# Kinetis 100 MHz Rev 1.x to Rev 2.x Migration Guide

This document shows differences and describes the details of migrating from Kinetis 100 MHz Rev. 1.x to Rev. 2.x.

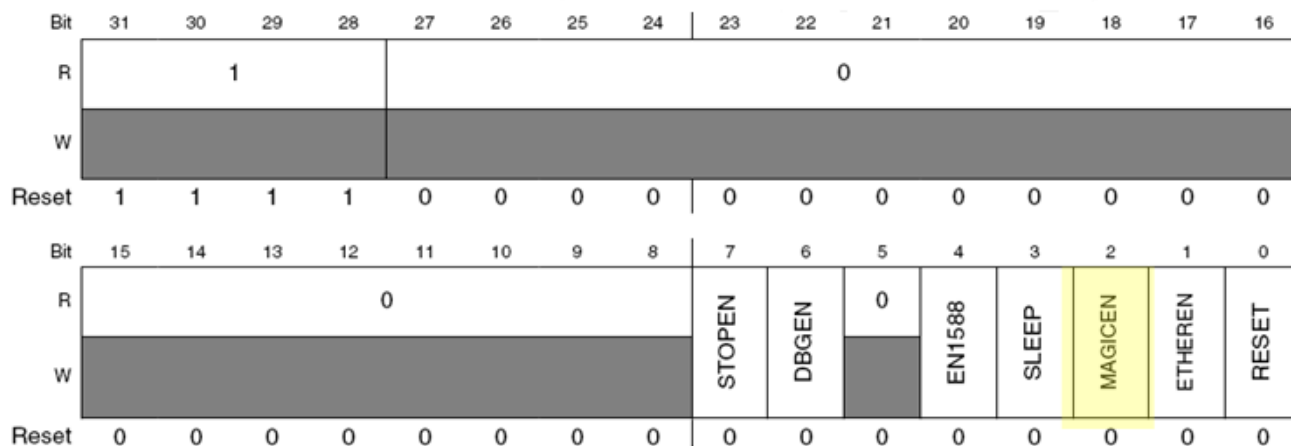
The ENET adds two new features, ENET\_ECR[DBSWP] and enhanced RxBD[VPCP], and changed functionality of ENET\_ECR[MAGICEN].
